Planning Heritage Design and Access Statement Addendum

New Farm, Back Lane, Alderton, Chippenham SN14 6NW

- (i) S.73 Amendment to planning permission PL/2022/01245: external revision to Plot 4 including revised fenestration and provision of conservation roof lights**
- (ii) Listed Building Consent: internal and external alterations to Barn 4 including revised fenestration, raising ground floor ceiling height and creation of first floor vaulted ceiling, and insertion of conservation rooflight (amendment to conversion approved under listed building consent PL/2022/01586)**

Figures 2 and 3. Extract from the Proposed GF and FF Plans

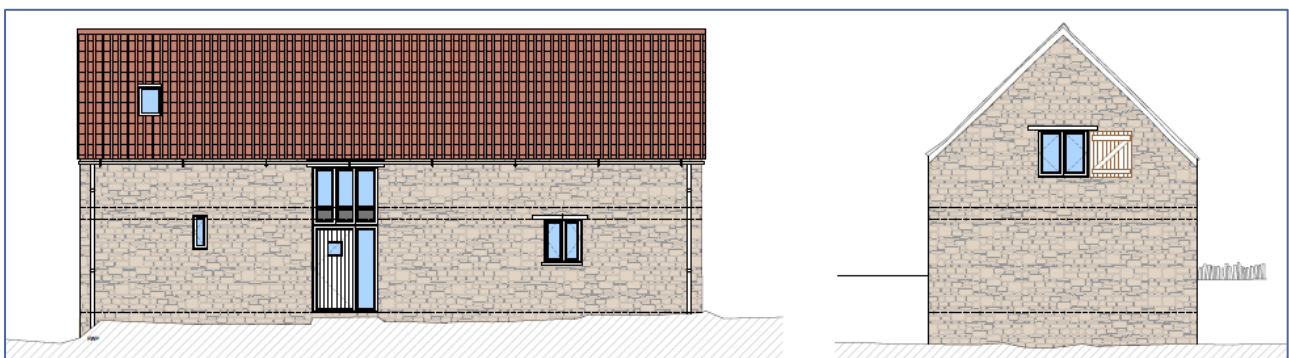
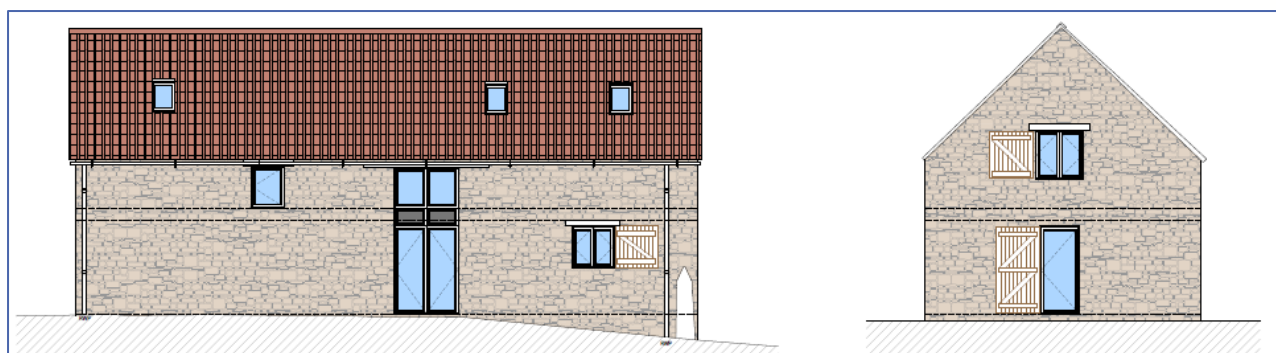
Following the acquisition of the wider application site, Ashford Homes have undertaken a detailed design development process and Building Regulations submission. This has revealed that the permitted Barn scheme only made provision for a 2.1m ground floor to ceiling height. Noting that standard minimum ground floor to ceiling heights in new build housing is typically 2.4m, the applicant has judged that the permitted ceiling height for Barn 4 is unacceptable from an amenity / end-user perspective. This matter has been further compounded by the floor zone (shown dashed on the approved drawings) being shown at less than 200mm deep, whereas 330mm is required for joists, plasterboard, decking and floor finishes.

Other technical issues relating to the approved drawings include the joist zone being shown running through the front door, which is not practically achievable, and the window to bedroom 2 on the north elevation being at floor level. The existing ground level appears to be shown with a dashed line on the approved elevations, although it is not annotated. The proposed finished floor level is over 0.5m lower in places, which would require the entire perimeter of the building to be underpinned and structurally waterproofed which would be a major engineering undertaking that would alter the character of the building and its relationship with the wider plot.

It is proposed to create internal ceiling heights of 2.25m which is generally considered to be the minimum to ensure amenity for occupants. Following proposed revisions to the roof structure, the first floor will benefit from a vaulted ceiling with new conservation rooflights to maximise light and amenity space. The proposals have also necessitated minor changes to the front door to ensure the first floor joists can be accommodated. The first floor window on the east elevation has also been reduced in size to accommodate the revised first floor level.

Relevant Extant Drawings	Proposed Replacement Drawings
Proposed Site Plan: Drg. 1938-L02-E	Proposed Site Plan: Drg. 1938-L02-E
Proposed Floor Plans & Section: Drg. 1938-Barn 4-01C	Barn 4-Proposed Floor Plans & Section: Drg. ALD-110-B
Proposed Elevations: Drg. 1938-Barn 4-02C	Barn 4-Proposed Elevations: ALD-111-A
